HISTORIC AND DESIGN REVIEW COMMISSION

December 21, 2022

HDRC CASE NO: 2022-577
ADDRESS: 305 LAVACA ST
LEGAL DESCRIPTION: NCB 708 BLK 8 LOT 2 (305 LAVACA TOWNHOUSES)
ZONING: RM-4, H
CITY COUNCIL DIST.: 1
DISTRICT: Lavaca Historic District
APPLICANT: Tim Rodgers/South Flores Construction
OWNER: Tony Pearson/305 LAVACA TOWNHOUSES
TYPE OF WORK: New construction of two 2-story duplex structures
APPLICATION RECEIVED: December 05, 2022
60-DAY REVIEW: Not applicable due to City Council Emergency Orders
CASE MANAGER: Rachel Rettaliata

The applicant is requesting conceptual approval to construct two, 2-story duplex structures at 305 Lavaca.

③ SITE PLAN
3/32" = 1'-0"

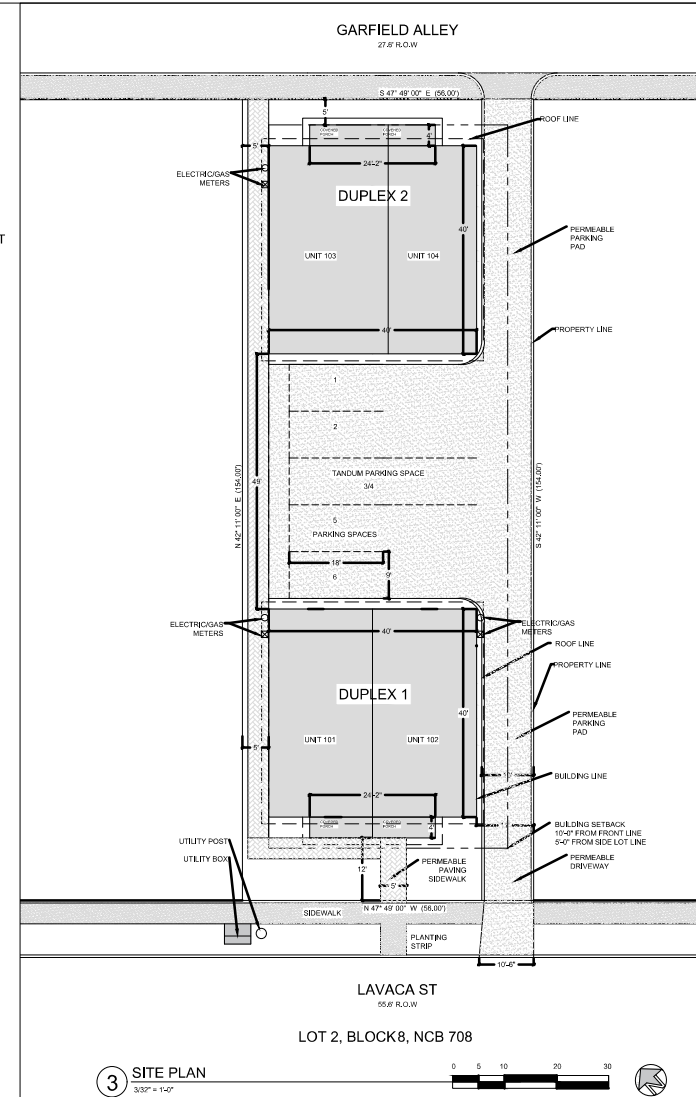
- d. **SETBACK & ORIENTATION (LAVACA)** – According to the Guidelines for New Construction, the front facades of new buildings should align with the front facades of adjacent buildings where a consistent setback has been established along the street frontage. Additionally, the orientation of new construction should be consistent with the historic examples found on the block. The applicant has proposed to construct two 2-story, duplexes residences at 305 Lavaca. The residences will be detached, with one duplex entrance facing Lavaca and the other duplex entrance facing Garfield Alley. The applicant has noted that the proposed setback from Lavaca will be 15 feet. The Historic Design Guidelines for New Construction stipulate that primary building entrances should be oriented towards the primary street and that front facades should be aligned with the front facades of adjacent buildings. Historically, homes have had frontage on both Lavaca and Garfield Alley. Staff finds that the applicant should provide a setback diagram noting the setbacks of neighboring structures.

- e. **SETBACK & ORIENTATION (GARFIELD ALLEY)** – According to the Guidelines for New Construction, the front facades of new buildings should align with the front facades of adjacent buildings where a consistent setback has been established along the street frontage. Additionally, the orientation of new construction should be consistent with the historic examples found on the block. The applicant has noted that the proposed setback from Garfield Alley will be 5 feet. Staff finds that the applicant should provide a setback diagram noting the setbacks of neighboring structures.

- p. **DRIVEWAYS** – Guideline 5.B.i for Site Elements notes that new driveways should be similar to those found historically within the district in regard to their materials, width, and design. Additionally, the Guidelines note that driveways should not exceed ten (10) feet in width. According to Guideline 8.F.iv for New Construction, a single, 10-foot driveway at one street frontage is recommended. Projects should first attempt to utilize historic curb cuts where extant. Additional entry points may be considered where there is alley access. The addition of driveways should not confuse or alter the historic development pattern. Do not introduce wide, shared driveways that appear visually similar to a street. The applicant has proposed to install a 10-foot-wide permeable driveway on the east property line, extending the full length of the property from Lavaca to Garfield Alley with a central parking pad with six (6) parking spaces. Staff finds the proposal inconsistent with the Guidelines and finds that a single driveway should be utilized for each duplex structure in lieu of the shared driveway that appears visually similar to a street.

- q. **FRONT WALKWAYS** – The Guidelines for Site Elements note that front yard sidewalk should appear similar to those found historically within the district in regard to their materials, width, alignment and configuration. The applicant has proposed to install a 5-foot-wide front walkway constructed of permeable pavers and a 5-foot-wide walkway constructed of permeable pavers along the length of the west property line. The submitted site plan does not feature a front walkway for the duplex oriented toward Garfield Alley. Staff finds that the applicant should reduce the proposed front walkway to feature a width of 4 feet and that access to the parking pad from the rear elevation should be utilized in lieu of the proposed walkway on the west property line.

- i. That the applicant provides a setback diagram showing that the proposed structure will not be located in front of the front façade wall planes of adjacent historic structures based on findings d and e.

- viii. That the applicant reduces the width of the proposed front walkway to 4 feet and that access to the parking pad from the rear elevation is utilized in lieu of the proposed walkway on the west property line based on finding q. The applicant must submit an updated site plan to staff for review prior to returning to the HDRC.

- ix. That the applicant modifies the site plan to feature a single driveway for each duplex structure in lieu of the shared driveway that appears visually similar to a street and submits an updated proposal to staff for review prior to returning to the HDRC based on finding p.

① FRONT ELEVATION- SOUTH

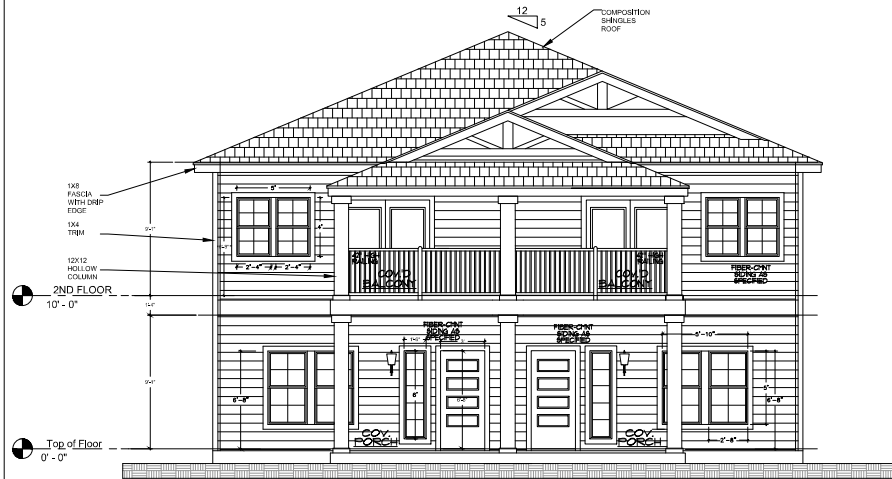
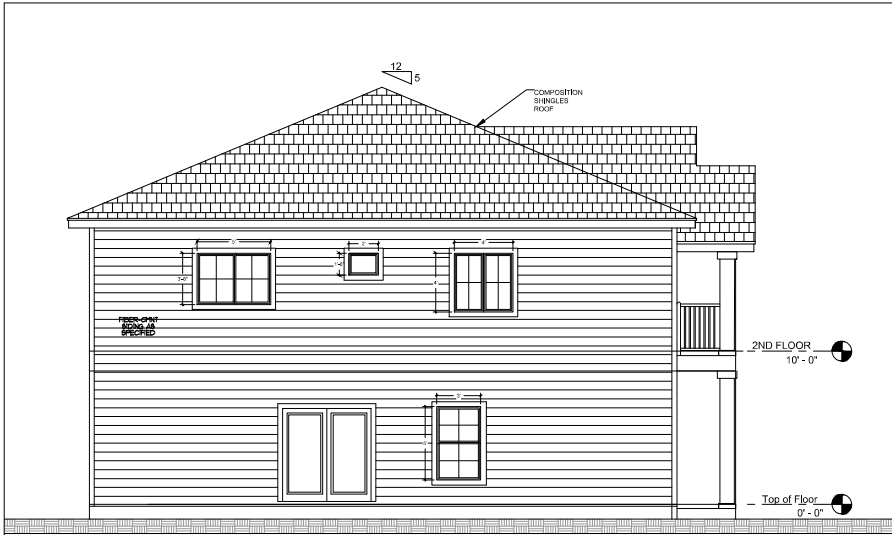
- g. **SCALE & MASSING** – According to Guideline 2.A.i for New Construction, new structures should feature a height and massing that is similar to historic structures in the vicinity. In residential districts, the height and scale of new construction should not exceed that of the majority of historic buildings by more than one story. The blocks of Lavaca and Garfield Alley feature one-story and two-story historic structures. Guideline 2.A.ii for New Construction states that applicants should utilize step-downs in building height, wall-plane offsets, and other variations in building massing to provide a visual transition when the height of new construction exceeds that of adjacent historic buildings by more than one-half story. Guideline 8.D.iii for New Construction states that applicants should separate building massing into distinguishable architectural bays consistent with historic buildings within the established context area. This is best accomplished through a change in wall plane or materials, or by aligning appropriately-scaled fenestrations. Staff finds that the applicant should reduce the overall massing and separate the building massing into distinguishable architectural bays consistent with historic buildings.

- m. **RELATIONSHIP OF SOLIDS TO VOIDS** – The applicant has proposed to install divided lite one-over-one windows on the duplex structures. The proposed fenestration pattern consists of sets of 2 ganged windows on the front facades, single, ganged, and small fixed windows on the side elevations, and single windows on the rear elevation. The proposed window proportions vary in size and all of the proposed windows do not appear to be in keeping with those historically found in the district. Guideline 2.C.i for New Construction states that window and door openings should be incorporated into new construction with a similar proportion of wall to window space as typical with nearby historic facades. Windows, doors, porches, entryways, dormers, bays, and pediments shall be considered similar if they are no larger than 25% in size and vary no more than 10% in height-to-width ratio from adjacent historic facades. Staff finds that the proposed fenestration should be updated to be more in keeping with the Guidelines.

- o. **FRONT PORCH** – The applicant has proposed to construct a double-height front porch on each of the duplex structures. The proposed front porches feature square columns, a second-floor porch handrailing, and decorative gable detailing. Staff finds that the proposed columns should be a maximum of 6"x6" in width and feature a traditional cap and base and chamfered corners and that the applicant submits details for the proposed columns and railing.

- ii. That the applicant reduces the massing and separates the building massing into distinguishable architectural bays consistent with historic buildings based on finding g.

- v. That the applicant proposes window sizes, patterns, proportions, and trim and sill detailing that are consistent with the Guidelines and historic precedents in the district as noted in finding m.

- vi. That the applicant submits details for the proposed porch columns and railing based on finding o. The proposed columns should be a maximum of 6"x6" in width and feature a traditional cap and base and chamfered corners.

3 SITE PLAN
3/32" = 1'-0"

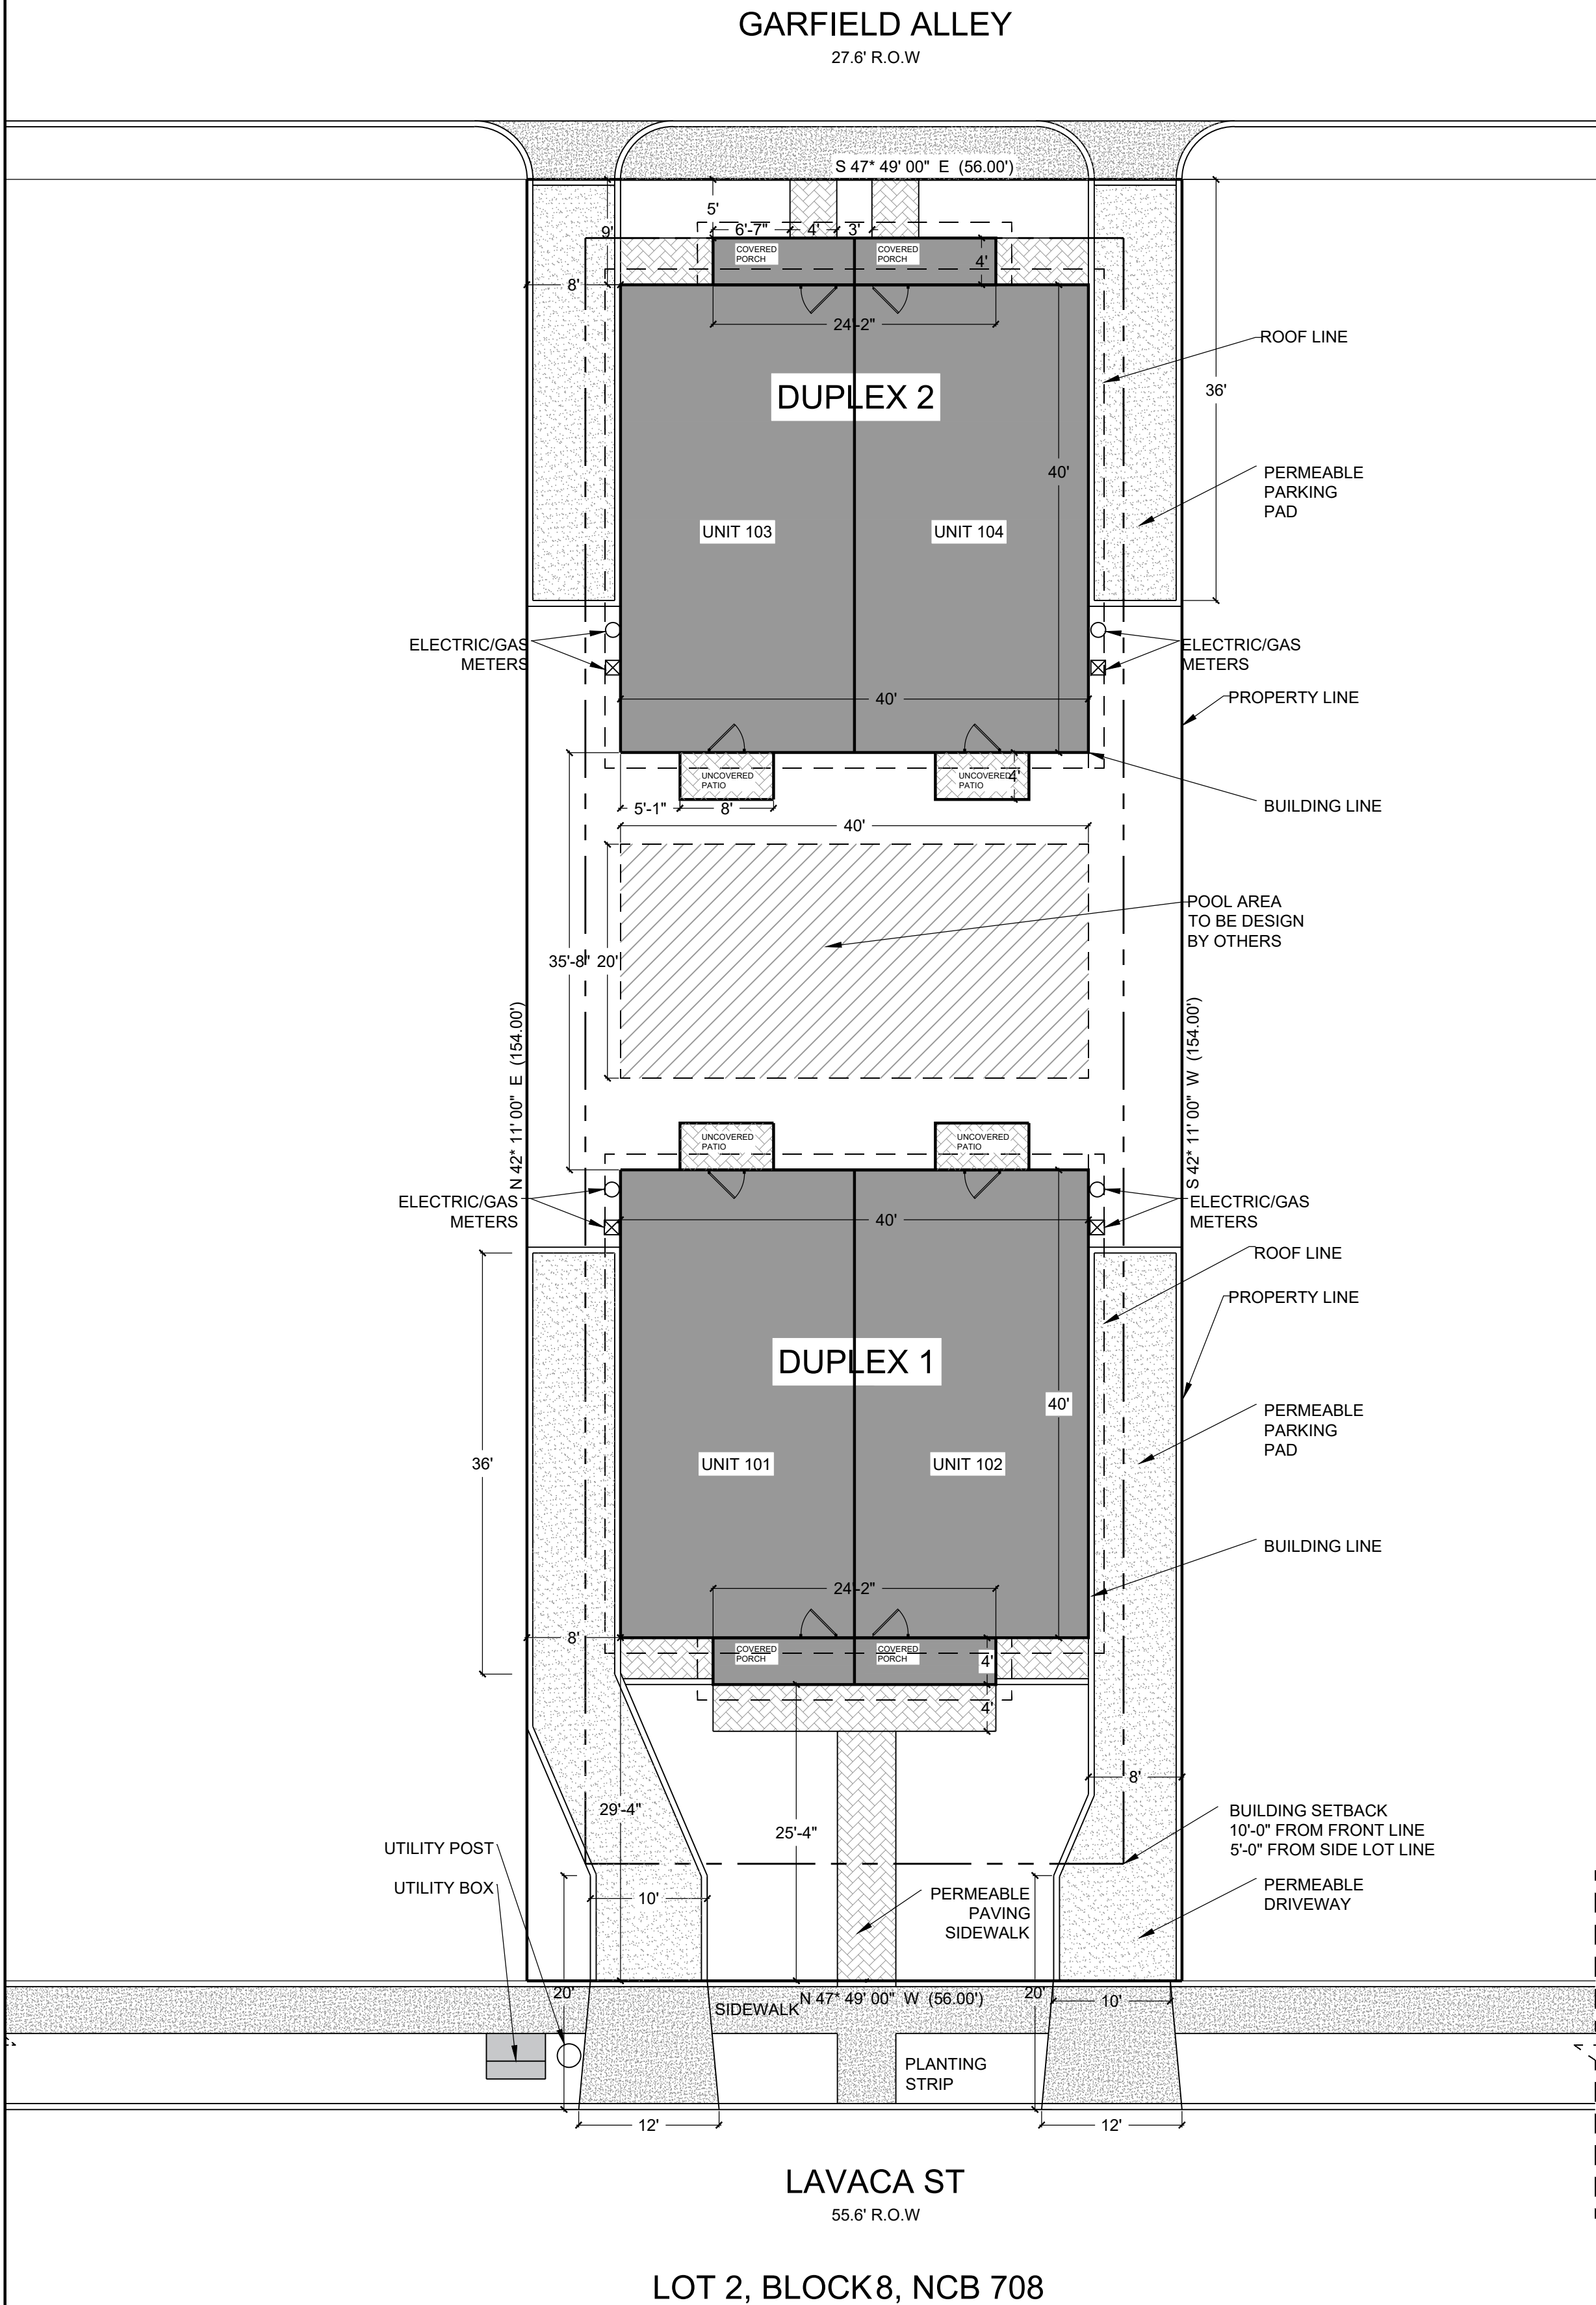
JF: Having two less curb cuts is a positive change and reducing the pool is helpful. A pool is very nice, but is there enough space for use of the site? You will need to provide a fence around the pool, you may want to include that on the site plan. There is building code or development services requirement for a fence due to safety.

JF: Having a more detailed landscaping plan would be good, showing fencing around the property and pool, if you are proposing any trees unless they are going in front of the Lavaca-fronting house.

JF: Yes, you will need to find out what zoning allows here and what zoning requirements are. On your site plan, you can also show where the pool equipment is, which will take up square footage, the mechanical equipment, those elements will need to be screened from view. And with 4 units, will we end up with 3 trash receptacles for each unit? That will require a lot of accommodation. Also, how does the front elevation on Lavaca address the surrounding homes, regarding setback, etc?

JF: An enlarged site plan showing more of the block and the setbacks of adjacent houses and what your setback is will be helpful. If there are 2-story structures, the height of those structures in relation to your structure will be helpful.

SC: I don't have much more to add. I think you will have better success relating the first and second floors to each other if the windows are all double hung. Going back to the site plan, we generally like to see the site plan showing the relationship between the proposed structures and the entire block.

SC: Is there the opportunity in the development of the site plan to introduce permeable surfacing in the parking area?
